# RESPONSE TO SUBMISSIONS

Construction of a Mixed Use Development including  
Commercial / Retail Uses and Hotel Accommodation

42 Honeysuckle Drive, Newcastle NSW 2300

**Report Reference No.:** 19581  
**Dated:** October 2020

**Figure 1 – Height Extract (Bates Smart pg. 7)**

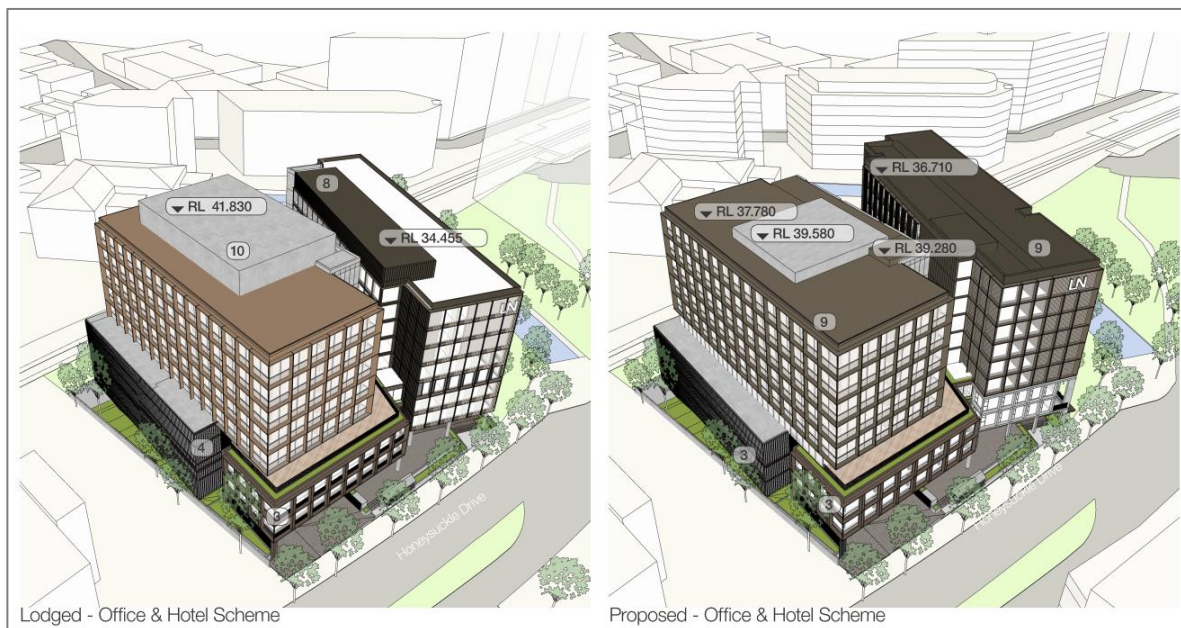
Figure 1 below and the plans at Appendix A demonstrate the proposed changes to height and built form. The height amendments are a result of the 4.5 floors of split level parking being reduced. In addition, the plantroom for both towers has been further incorporated into the towers and resulting in the overall building level of the commercial east being lowered, with the highest point being reduced from RL 41.830 to RL 39.580 (reduction by 2.25m at highest point).

**Figure 2 – North Elevation Comparison**

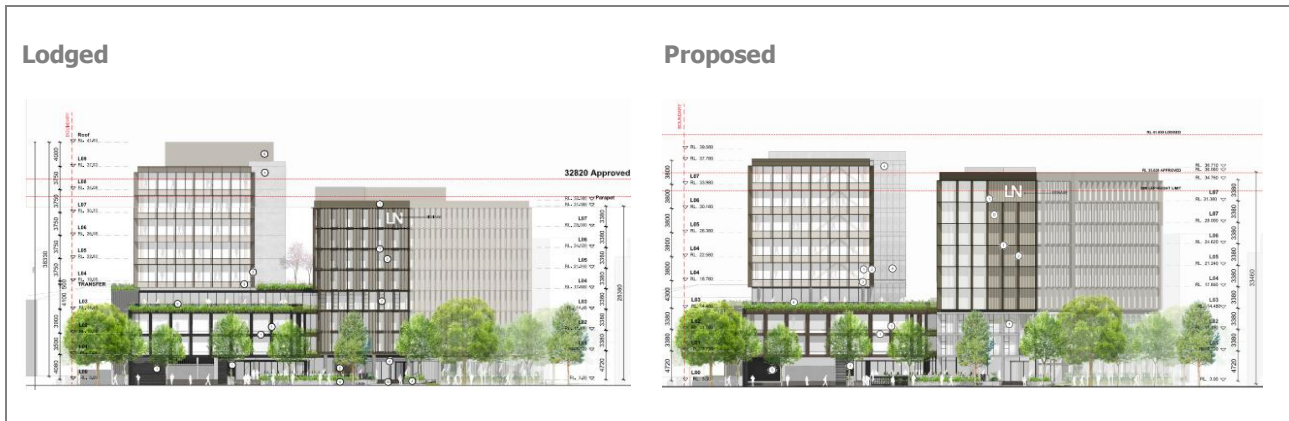
Full details of the exterior and façade changes are provided at Appendix A, a comparison is shown in Figure 2 – 5 below. It is considered that the proposed amendments result in an improved design outcome and reduce overall bulk and scale.

**Figure 6 – Height Extract from Design Report (Bates Smart pg. 32)**

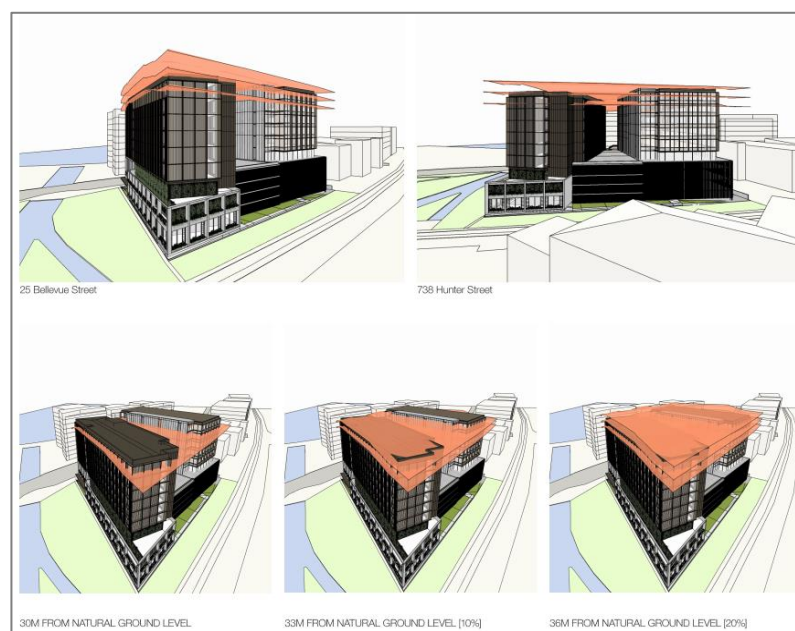
In comparison to the previously approved scheme, the form of the building above the podium is split into two forms, rather than one U-shaped plan form. As a result of the two forms, the proposal is read as two elements which breaks down the bulk and scale of the development and the two forms allow for an additional view corridor to the north to be maintained through the site, in comparison to the previous development. This was described in Section 6 of the submitted design report extract below (Figure 6) and was presented to the NSW Department of Planning, Industry and Environment (Amy Watson) and GA on the 11 November 2019 prior to lodgement.

The DRP confirmed the previous form is an improvement on the previous scheme and were supportive of the additional height. The revised maximum height and lower podium height were supported give the overall bulk and scale appearance has been reduced, now reading as two towers rather than one U-shaped mass. The alignment of the hotel element along the western boundary has provided a view corridor through the centre of the podium from 25 Bellevue Street where there was previously an unbroken building form.

Figure 7 – Equinox March 21 (Bates Smart pg. 52)

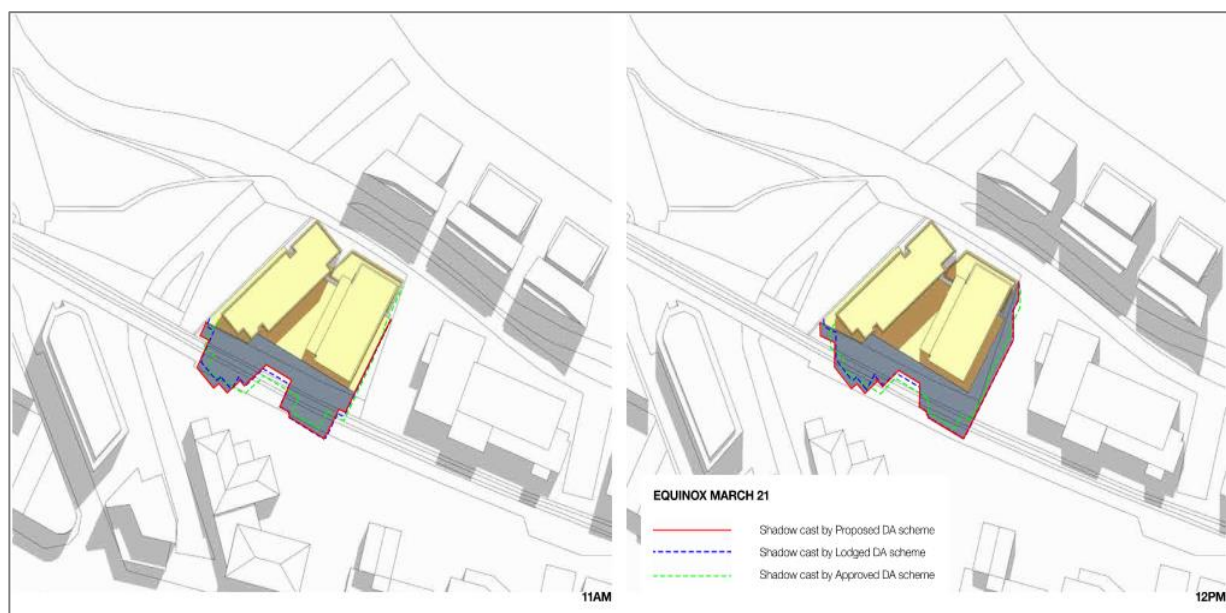
Additional solar comparison drawings have been prepared and attached at Appendix A, the blue outline shows the shadow cast for the lodged DA scheme (SSD10378), the green outline shows the shadow cast for the approved DA scheme (SSD8440) and red outlines the proposed amendments scheme. Shadow diagrams reflecting winter solstice and equinox from 9am – 3pm are provide in the plans at Appendix A, Figures 7 & 8 below represent the greatest impact.

As illustrated by Figure 7 and Figure 9 it is evident that the proposal under the proposed amendments, does not materially impact the neighbouring properties, (further assessment diagrams at Appendix A). The proposal will not result in an increased solar impact to residents at 25 Bellevue Street outcome due to the redesign which has resulted in a reduced bulk.
